Alesis ADAT Proprietary Multichannel Optical Digital Interface

ADDENDUM February 2001

2X Sample Rate (96kHz) Specification

Version 1.0 - February 3, 2001

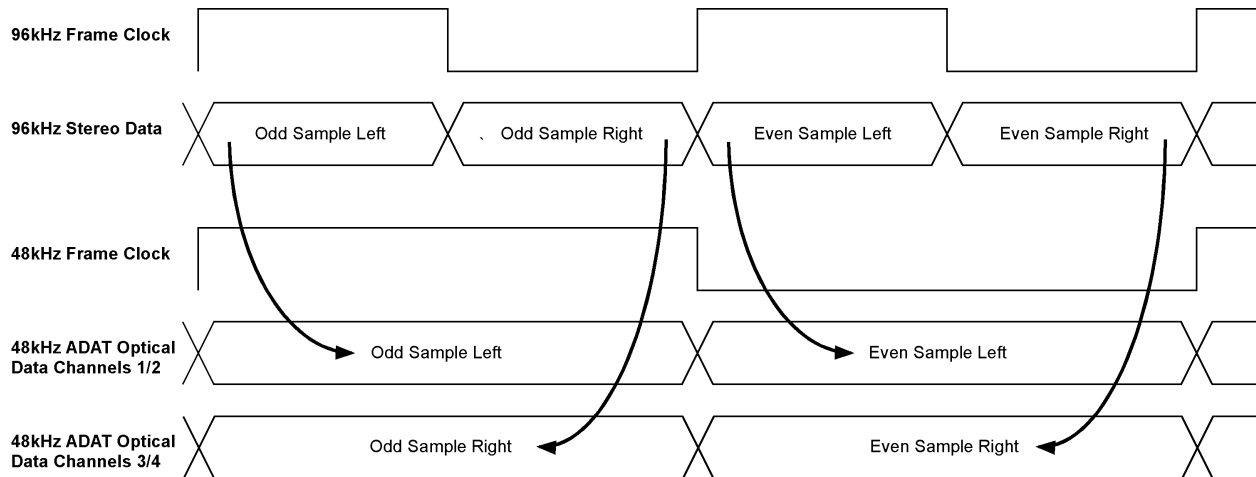
The ADAT Multichannel Optical Digital Interface specifies 4 user bits per frame, labeled bits 0-3. Bit U0 is defined as Time Code, and U1 as MIDI data. This document specifies user bit U2 implementation as follows:

For 1X (48kHz) operation, U2 is to be held at logic low
For 2X (96kHz) operation, U2 is to be held at logic high

This is clearly an under-utilization of user bit U2, as it is capable of transmitting 48,000 bits per second of information. However, simply setting the bit high or low negates the need for a sample-synchronous receiver or transmitter implementation, and allows a receiving system to poll the user bit on a relatively infrequent basis to determine incoming sample frequency.
